Access Compliance Report

Public Rights-of-Way

Intersection ID: 14662	Main Street: S_KINGS_DR	Cross Street: BALDWIN_AV	Location: NE
ADA ID: 4660A6E52CEE	Ramp Type: ParaDiag	Initial Pass/Fail: Fail	Overall Compliance: No
			Severity Score: 13.75

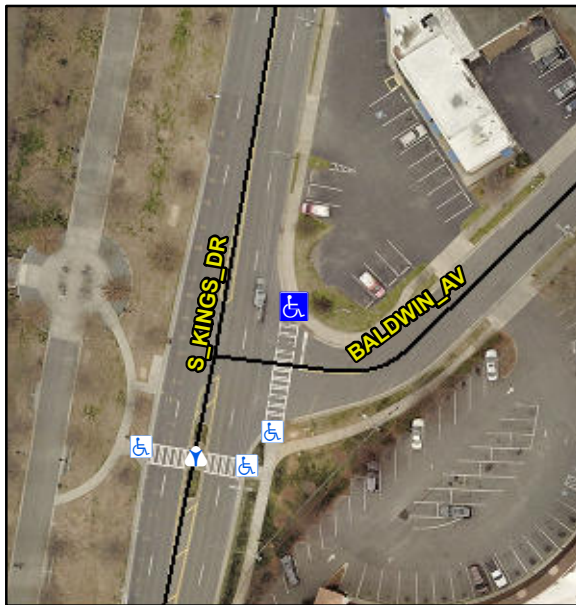
RT RP < 5%

R304.3.2, R304.5.3

Compliance	Description	Data	Compliance	Description	Data
N/A	Ramp Length LT (in)	56.0	N/A	Ramp Length RT (in)	45.0
Yes	Ramp Width LT (in)	70.0	Yes	Ramp Width RT (in)	70.0
No	Ramp Slope LT (%)	10.8	Yes	Ramp Slope RT (%)	3.6
No	Ramp XSlope LT (%)	3.0	No	Ramp XSlope RT (%)	4.3
N/A	Landing Length (in)	N/A	N/A	DWS Provided?	N/A
N/A	Landing Width (in)	N/A	N/A	DWS Contrast?	N/A
N/A	Landing Slope (%)	N/A	N/A	DWS Length (in)	N/A
N/A	Landing X Slope (%)	N/A	N/A	DWS Full Width?	N/A
N/A	Landing Curb? (Y/N)	N/A	N/A	DWS Offset (in)	N/A
N/A	Shared Landing?	N/A			
N/A	Gutter Ponding?	N/A	N/A	Gutter Slope (%)	N/A
N/A	Gutter Lip Ht (in)	N/A	N/A	Gutter X Slope (%)	N/A
N/A	Painted X Walk1?	No	N/A	Painted X Walk2?	Yes
	X Walk 1 Direction	To W		X Walk 2 Direction	To S
N/A	X Walk 1 Width (in)	N/A	N/A	X Walk 2 Width (in)	103.0
	X Walk 1 Slope (%)	3.2		X Walk 2 Slope (%)	1.1
	X Walk 1 X Slope (%)	0.1		X Walk 2 X Slope (%)	3.4
N/A	Ramp inside XWalk1?	N/A	N/A	Ramp inside XWalk2?	Yes

Remove & Replace Curb Ramp With Two New Directional Ramps or Equivalent.
